ORNL/TM-9889

Summary of the Technical Review of the Safety Analysis Reports for Packaging (SARP) for the Transnuclear Transport/Storage Casks: TN-BRP and TN-REG

Date Published - July 1986

Fig. 5. Location of EP fuel assemblies for case BRP6 loading. Parentheses denote EP assemblies in bottom portion of basket.

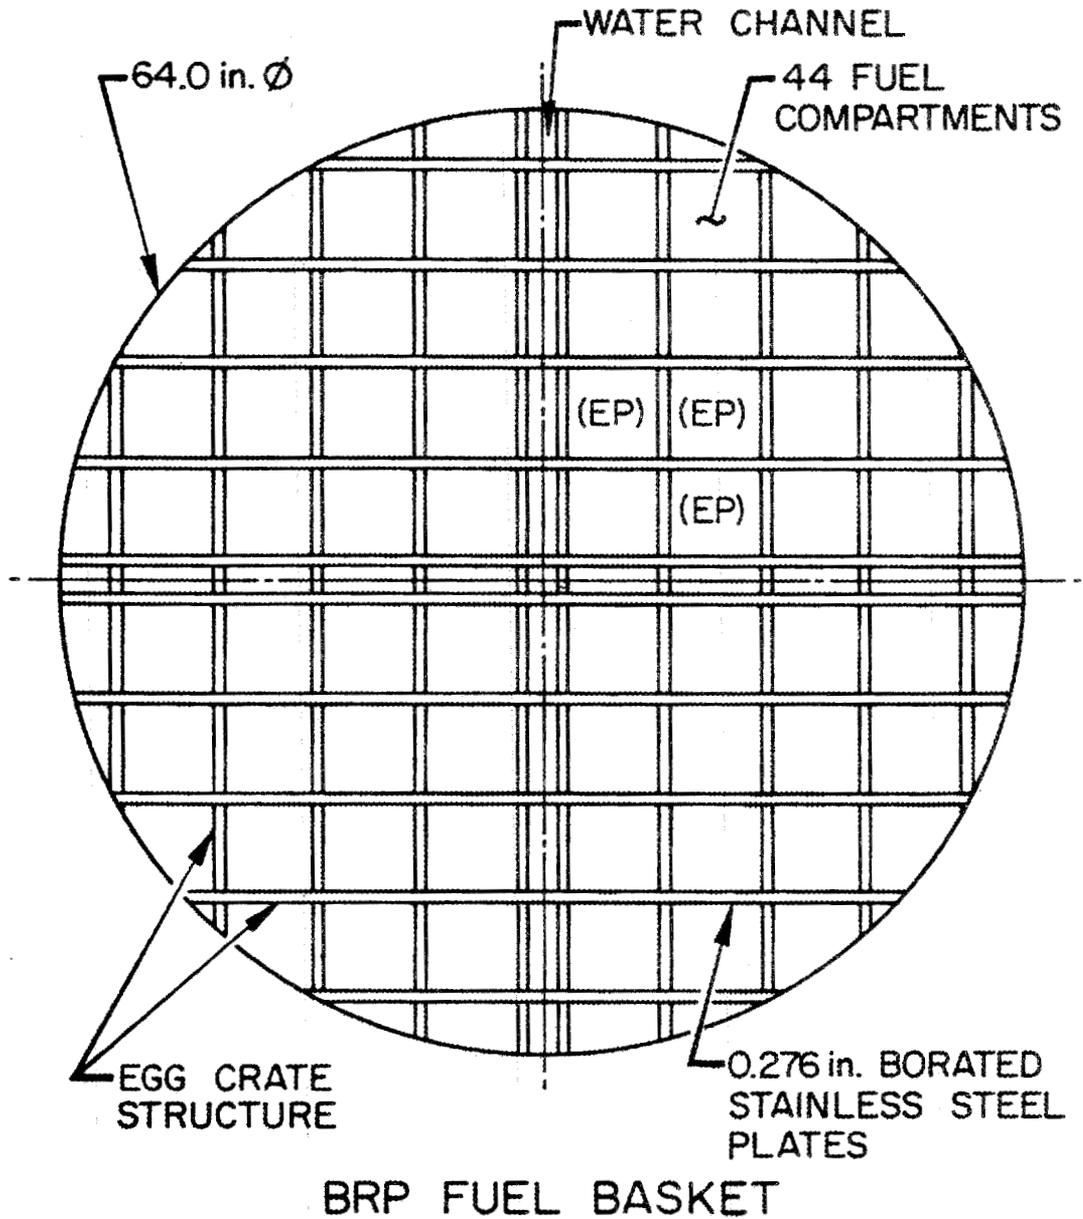
The first calculations, which were performed before submittal of a final SARP, used the early design boron specification of 1.56 wt % in the basket. Table 1 presents the earliest calculated results that provide an indication of the low sensitivity of k_{eff} to the boron above 1.3 wt % and to the specular reflection boundary condition. Table 2 provides results for a series of calculations performed to determine the EP assembly configuration that provides the highest k_{eff} value. Figures 1-6 show the EP loading configurations used where all blank compartments are assumed to hold Type F assemblies. Figure 5 illustrates the fuel configuration that gave the maximum k_{eff} value. Instead of the fuel configuration of Fig. 5, the SARP model assumed four infinitely long EP assemblies (or eight actual assemblies) to be located in the four central compartments. This was deemed acceptable because (1) eight rather than three assemblies were assumed in the SARP model, (2) the SARP model is more consistent with the specified loading pattern, and (3) the k_{eff} value obtained with the optimum (Fig. 5) loading is in basic agreement with the value reported in the SARP.

Fig. 7. Comparison of predicted time-temperature history during and following fire accident conditions for TN finite element model and ORNL finite difference model.

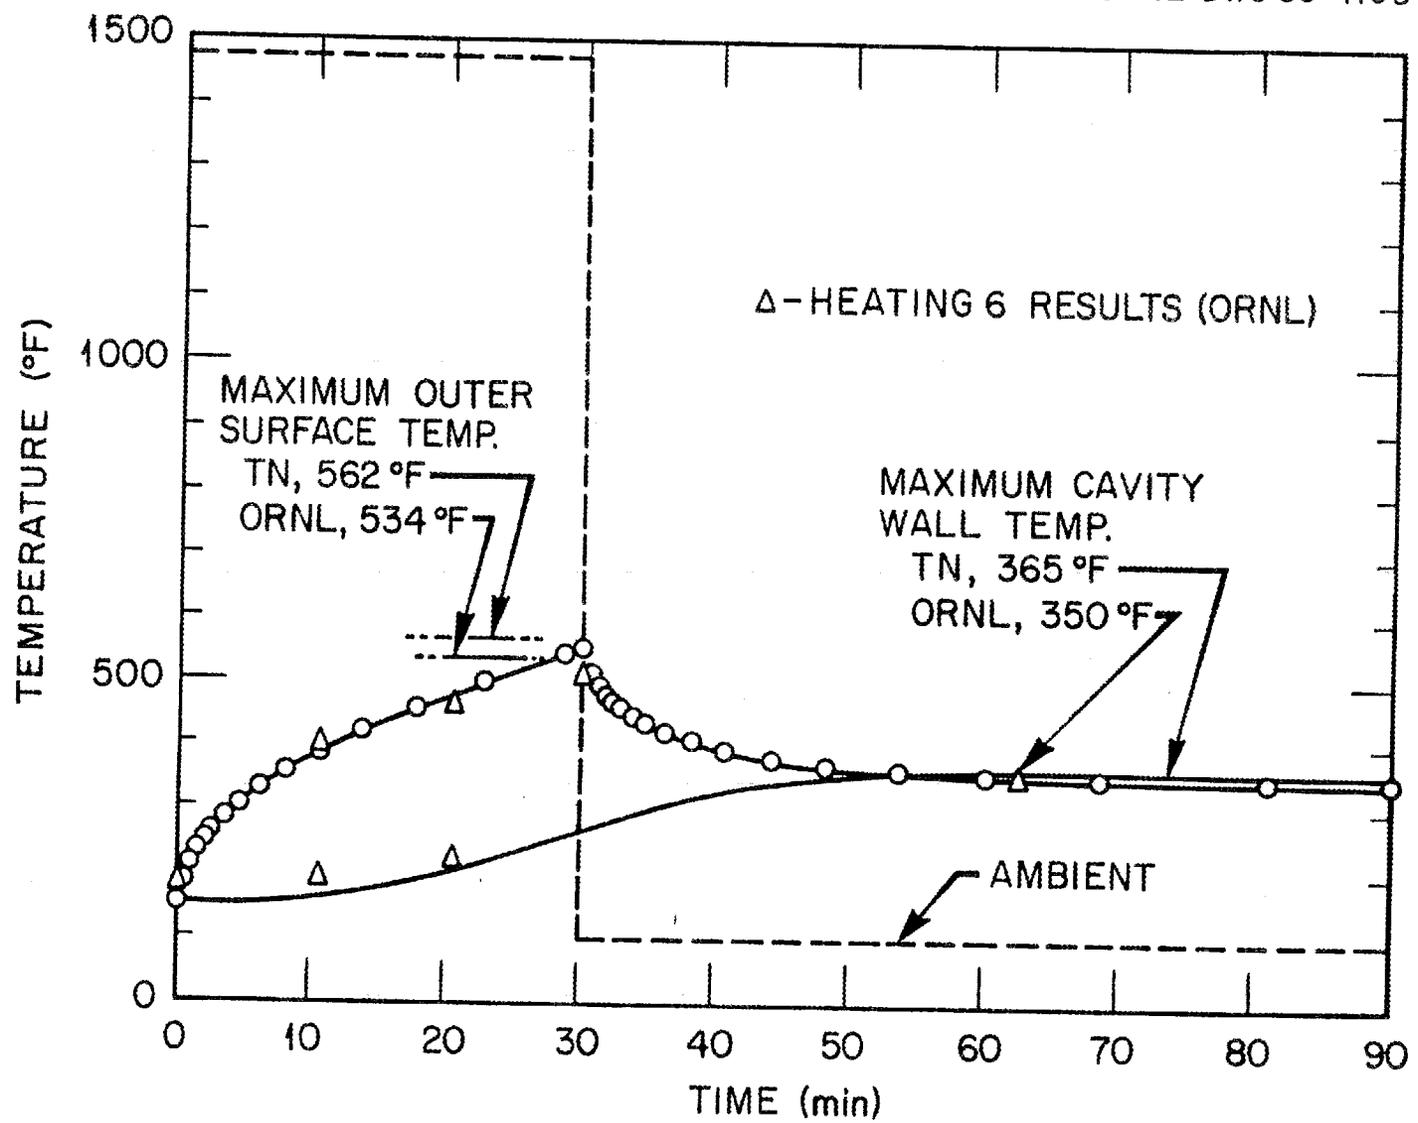
Preliminary cask thermal analyses with SCALE⁹ were performed for both steady state and 30-min fire transient. Several simplifying assumptions were used, and the results indicated agreement with trends and approximate confirmation of values reported by TN. Selected ORNL results are compared to TN's evaluation in Fig. 7.

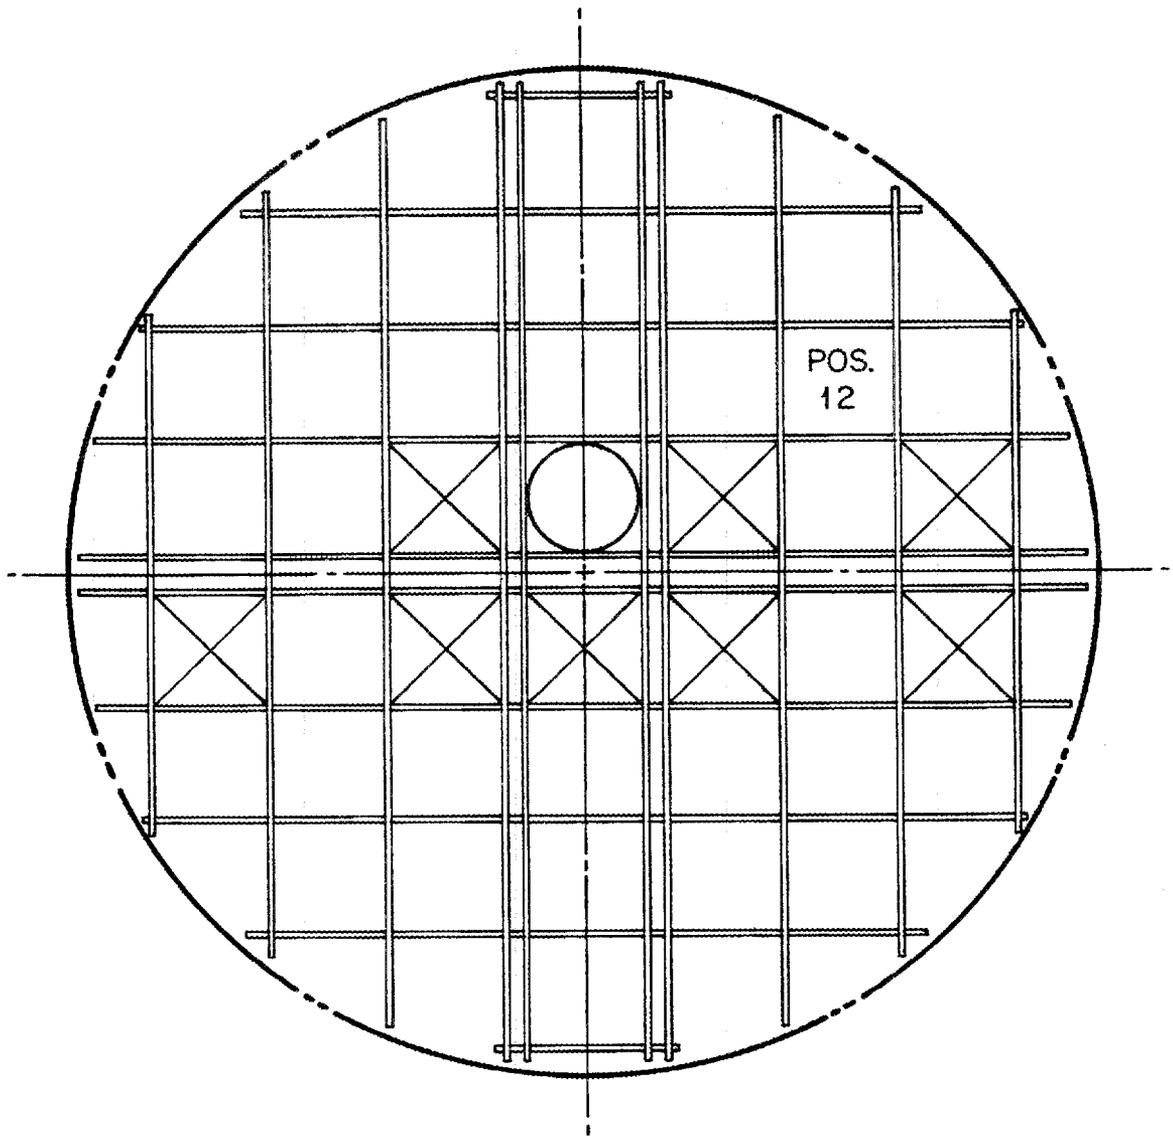
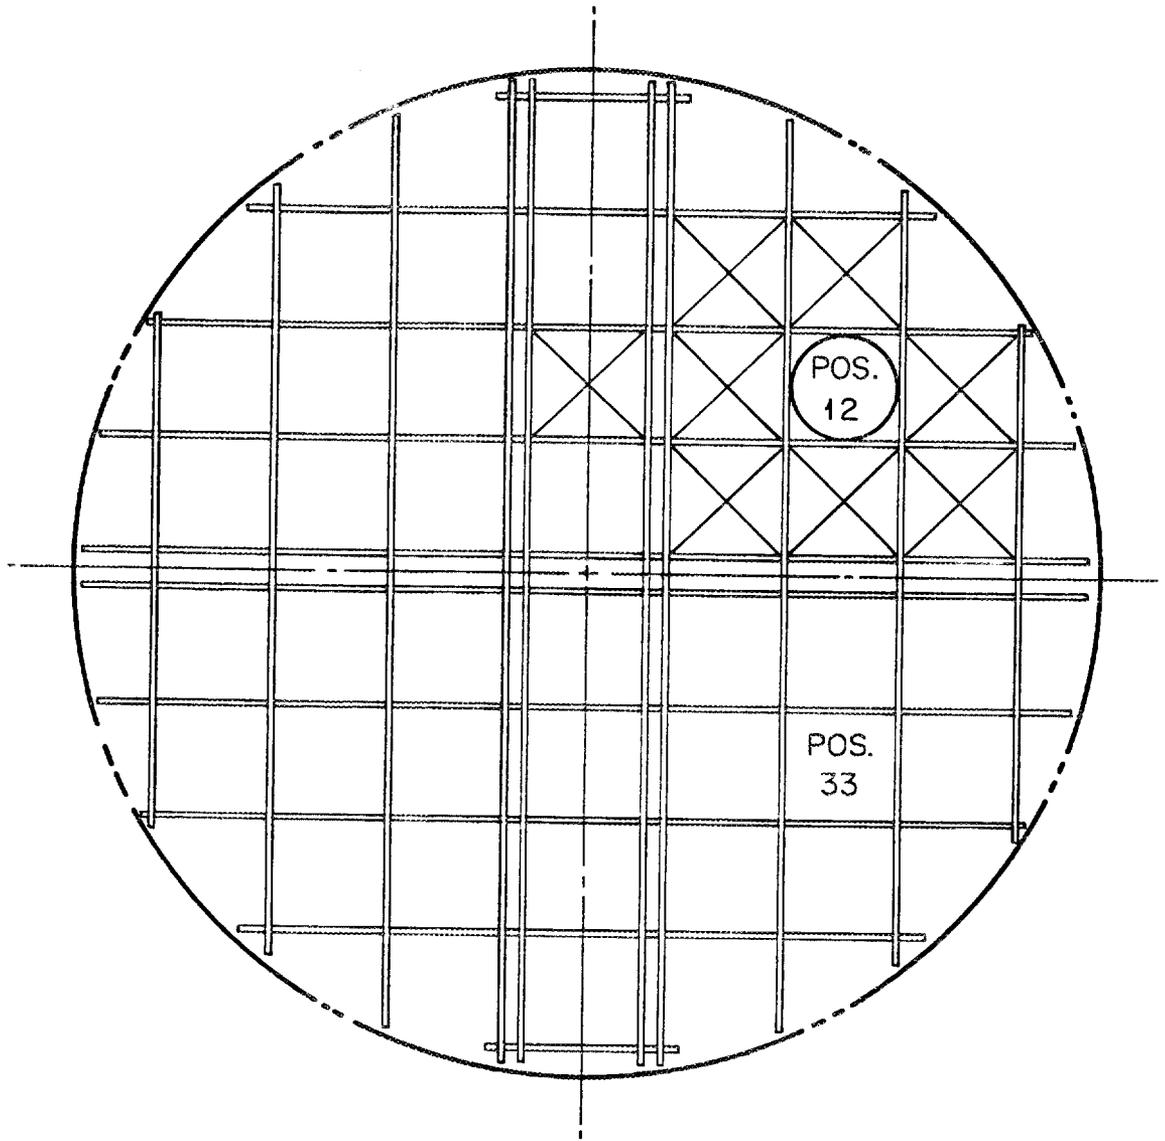
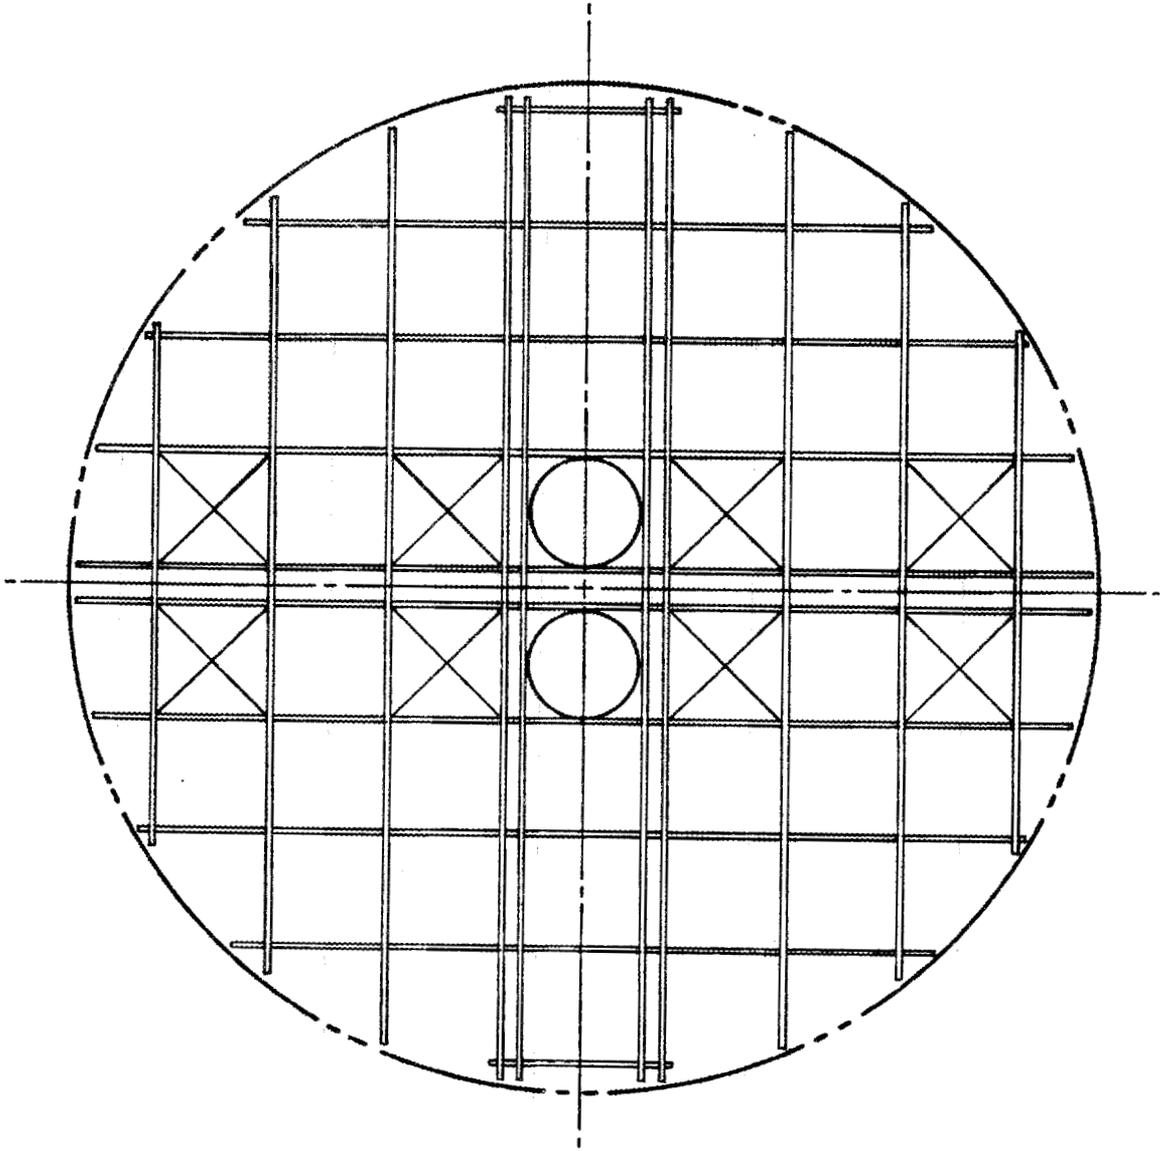
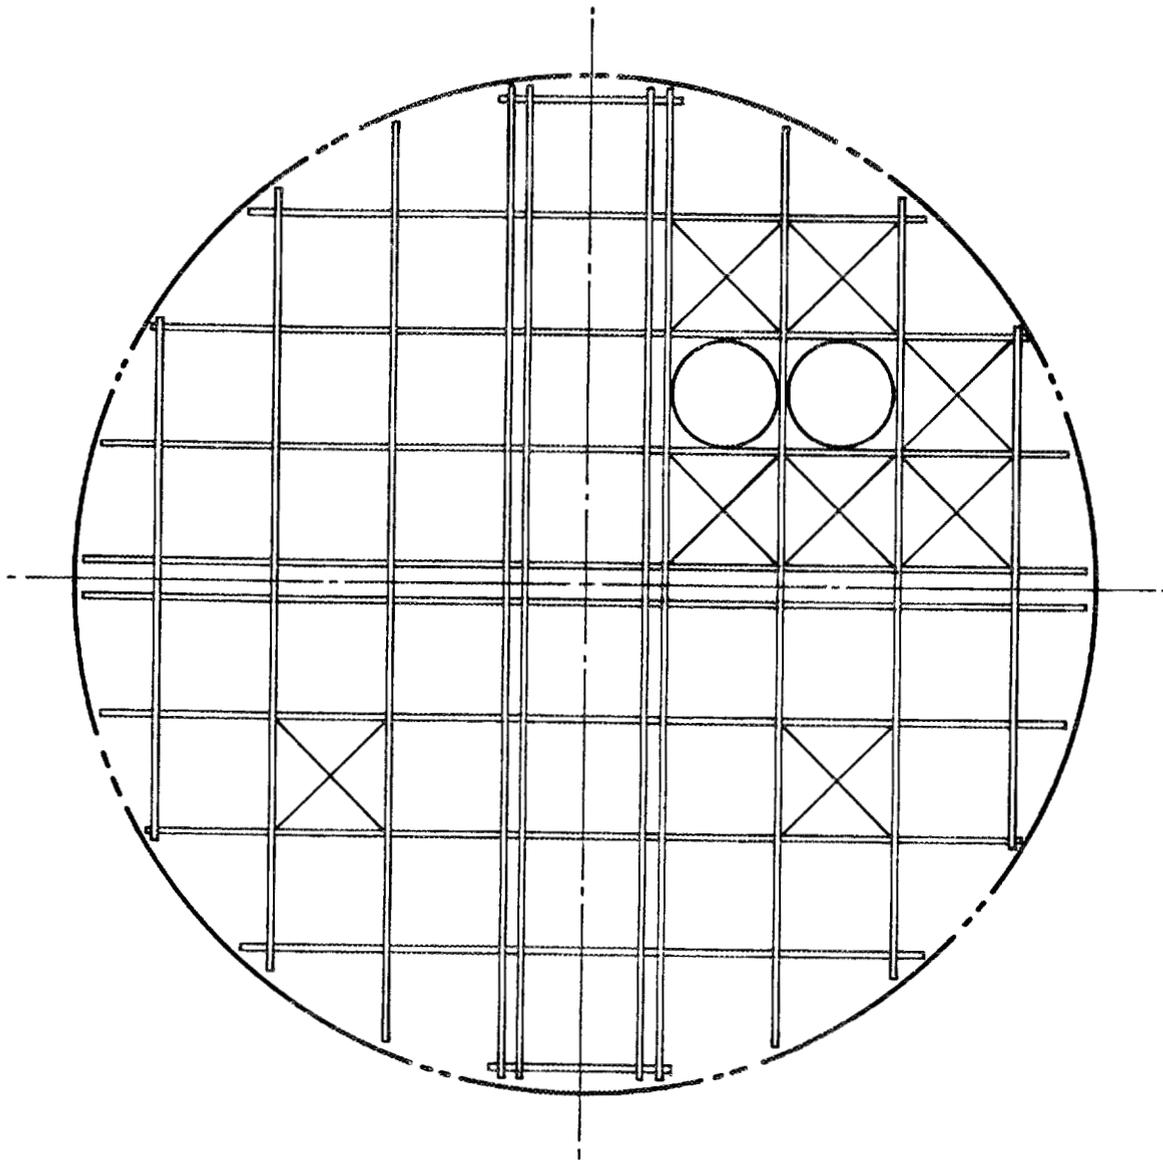
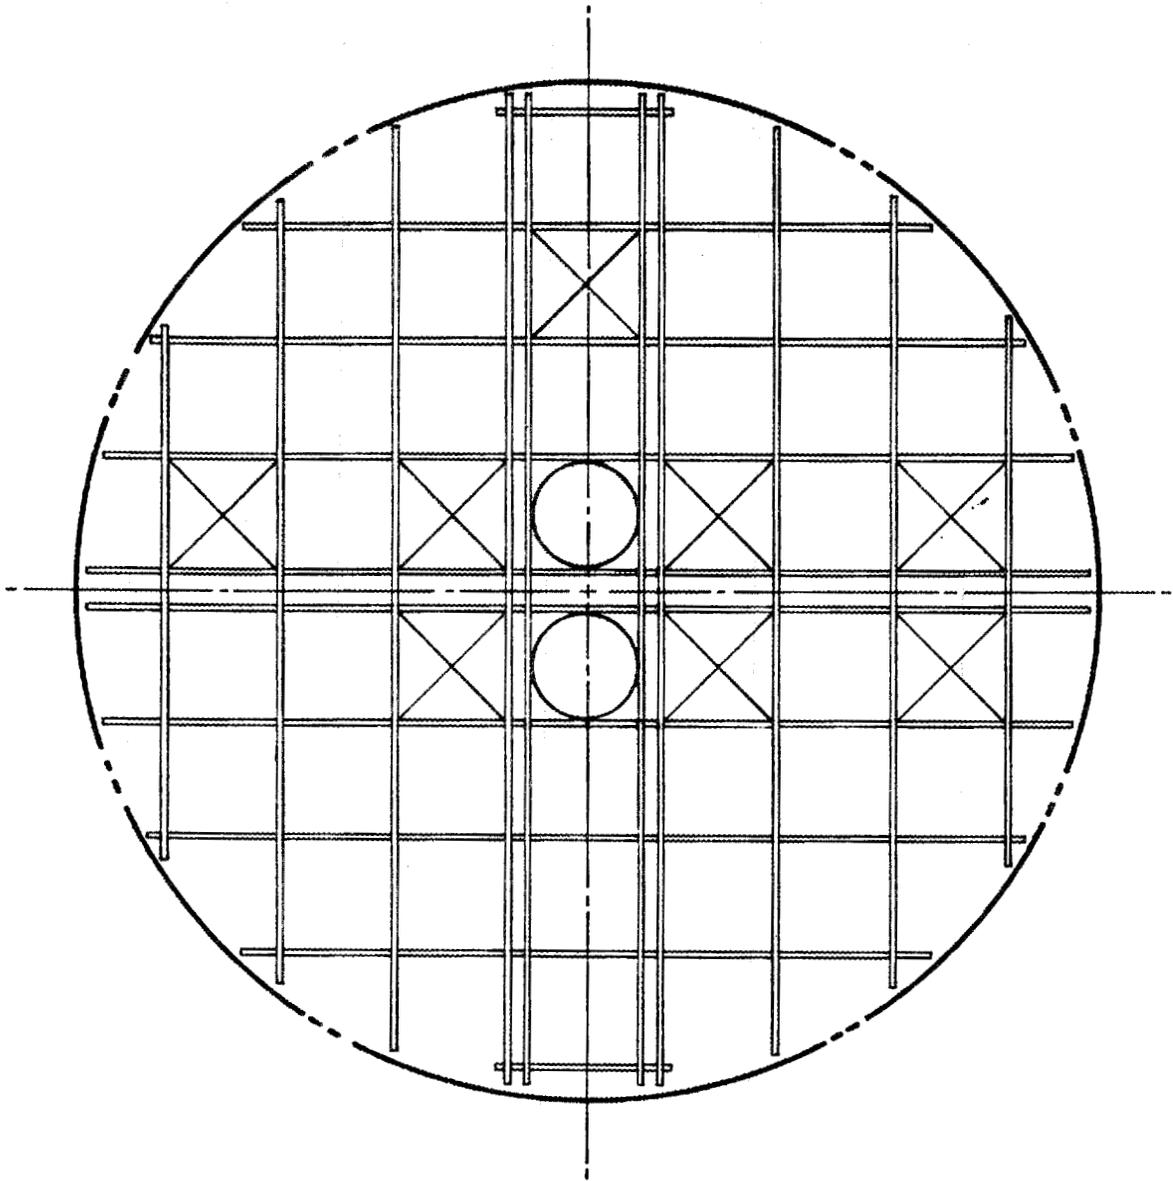
The basket loading configurations used for the confirmatory criticality analyses are shown in Figs. 8 - 12. The loading configuration of Fig. 8 is that prescribed in Chap. 7 of the August SARP submittal³⁹ which had only one assembly without a BP cluster, while Fig. 10 shows the loading configuration assumed by NEAD review staff after being informed by WVNS that two (instead of one) assemblies had no BP rod cluster. Conservative case loadings relative to Figs. 8 and 10 are shown in Figs. 9 and 11, respectively. Only after the final SARP submittal was the actual loading configuration used by TN available for calculation. This loading pattern is slightly different from that assumed in Fig. 10 and is shown in Fig. 12. Although Figs. 11 and 12, respectively, provide the correct conservative case and intended loading of the cask, results corresponding to Figs. 8-10 are also provided because they show reactivity effects that apply to, but were not later demonstrated for, the final configurations of Figs. 11-12.

The first calculational set models an infinite square array (void between casks) of closed, water-filled casks per the conditions of 10 CFR Pt. 71. The results presented in Table 8 indicate that (1) the k -eff values show little sensitivity to the boron content in the basket between 1.5 wt % and 1.7 wt %, (2) full density water provides the optimum moderating conditions, and (3) removal of all BP clusters (case REG4) or assuming the conservative case loading scenario (case REG2P, Fig. 11
